PLAN COMMISSION AGENDA

STAFF REPORT

Agenda Item: **6.a.**

Fletcher Arms Parking Lot Improvements

SHEET CONTENTS
 STORM SEWER DRAINAGE AREAS

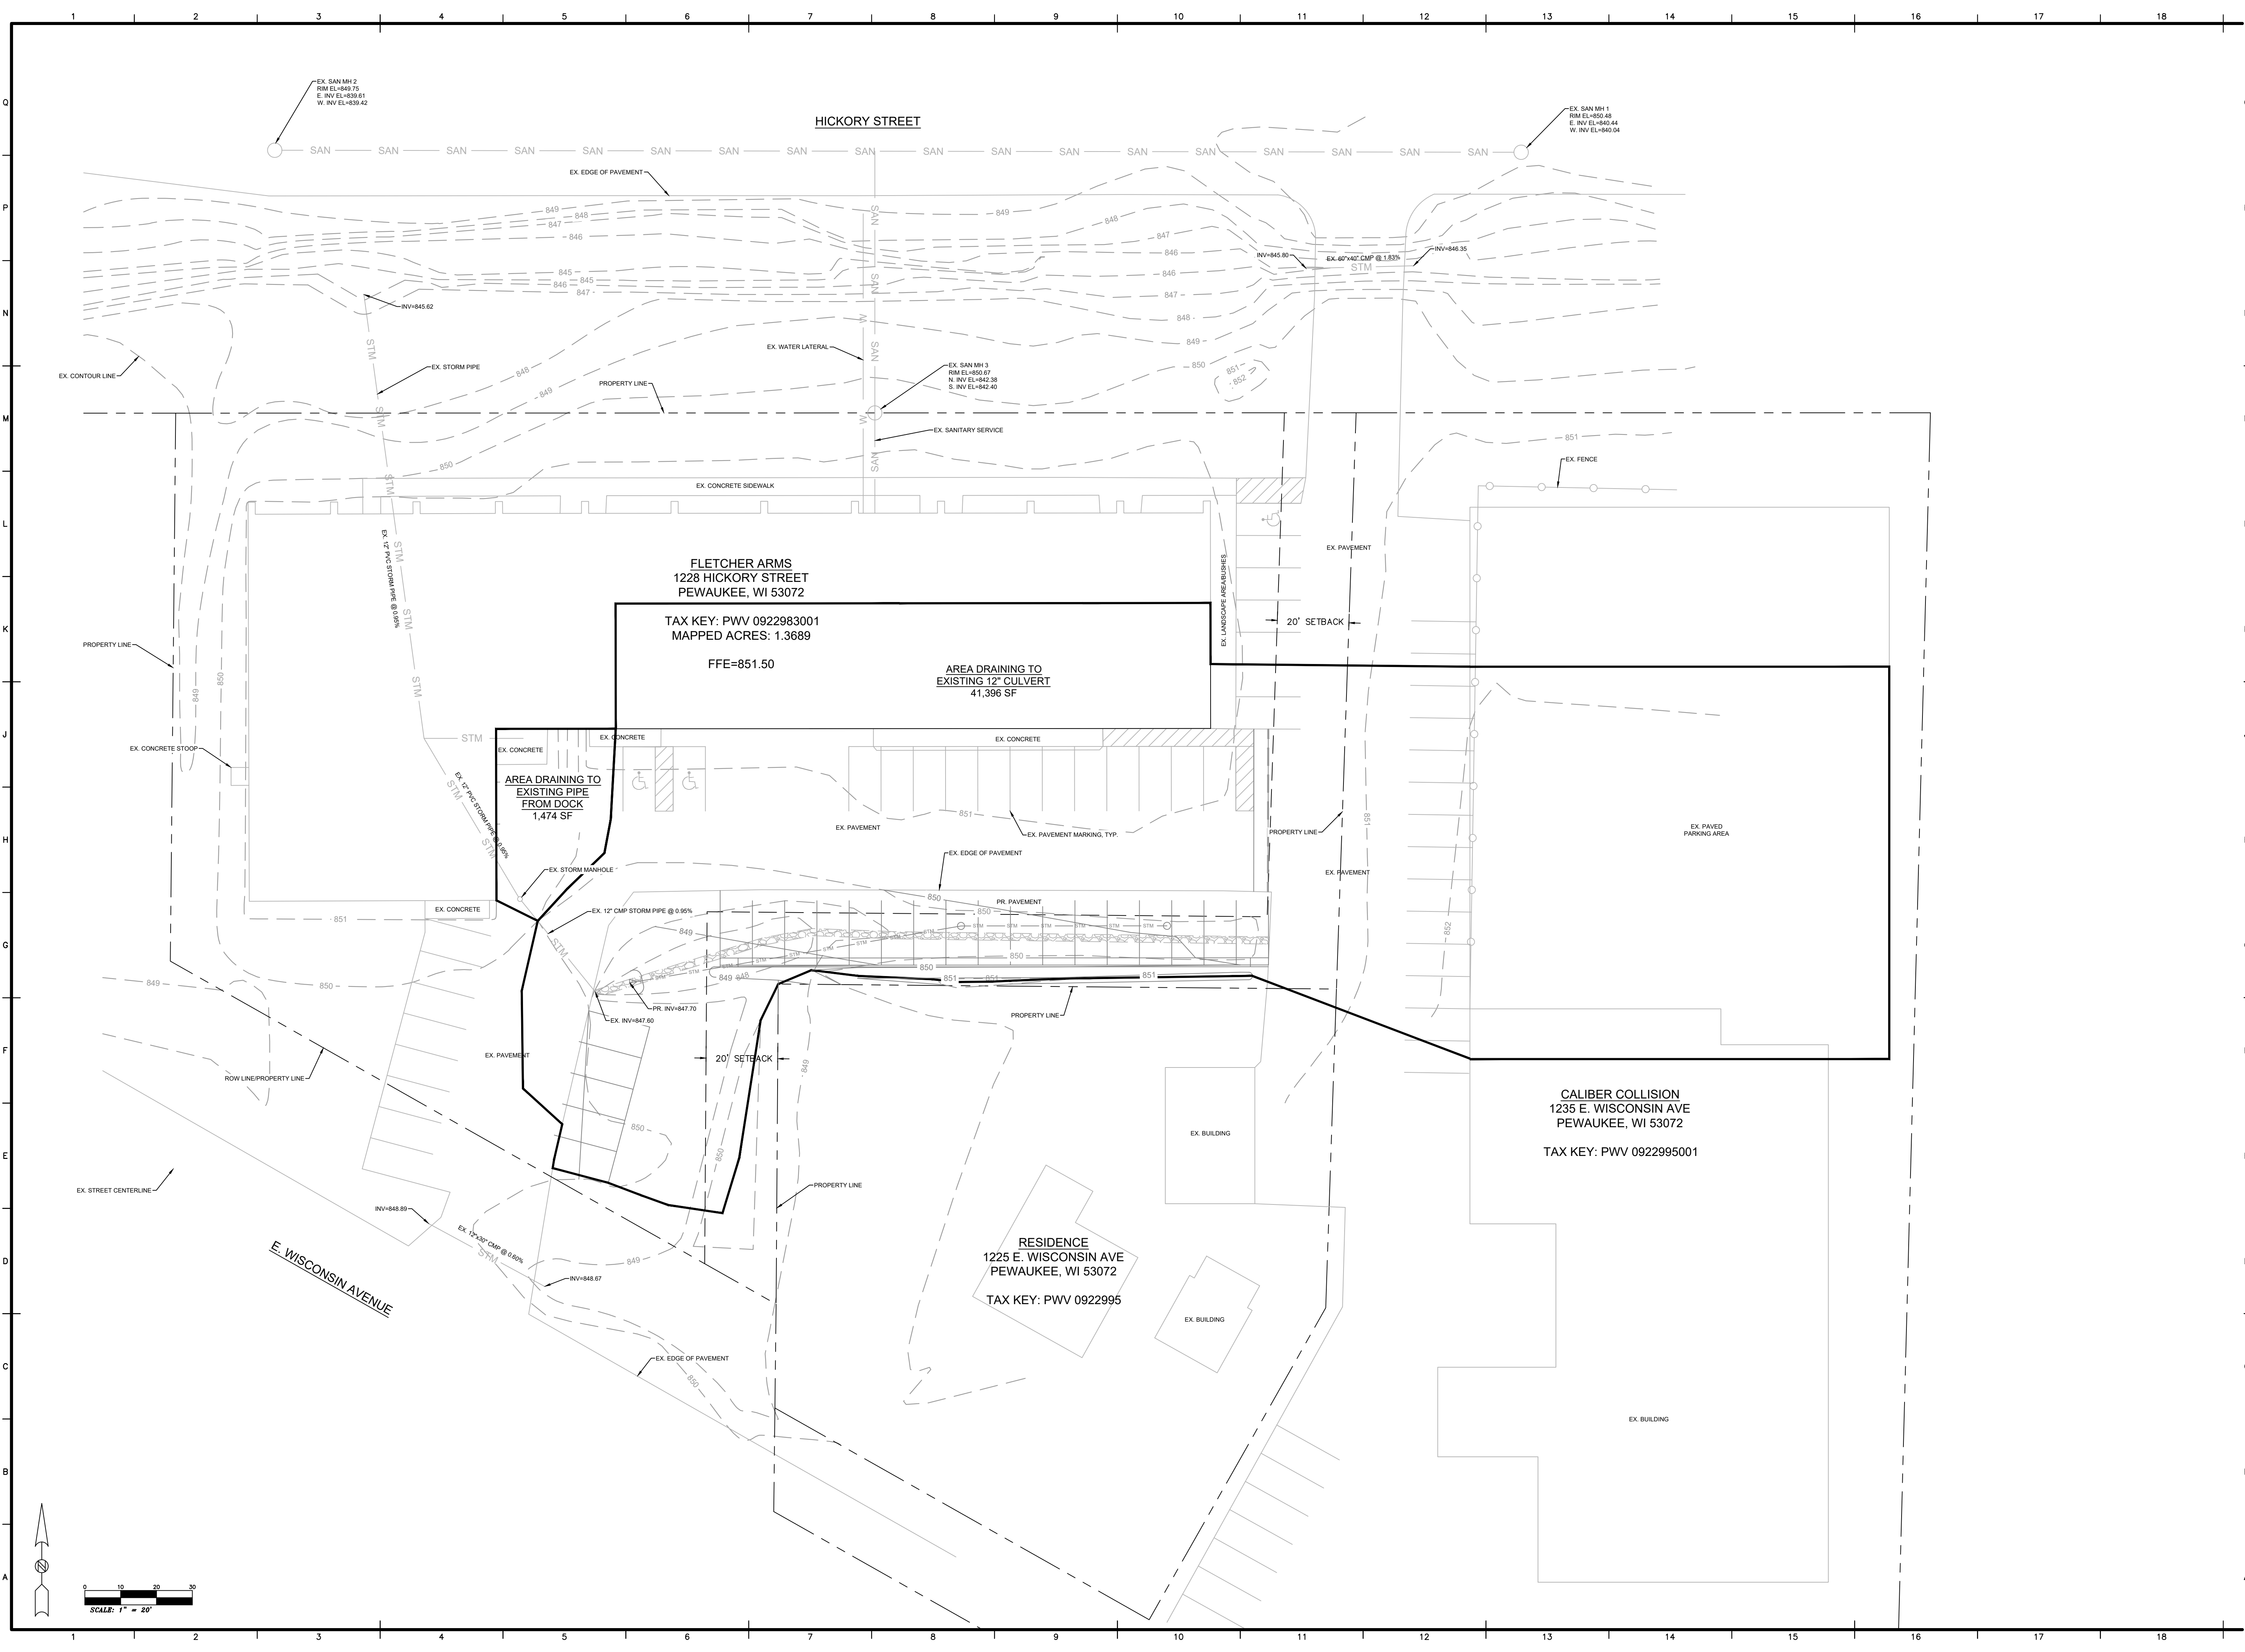
- Resolution of any zoning matters identified by the Village Planner
- Submission of digital video that shows the pipe under the building is in sound condition and operational to be able to accommodate the anticipated flows. If pipe is not in sound condition and could compromise flow of the stormwater in the parking lot, the pipe will have to be re-routed around the building, with Village Engineering approval of the plans.
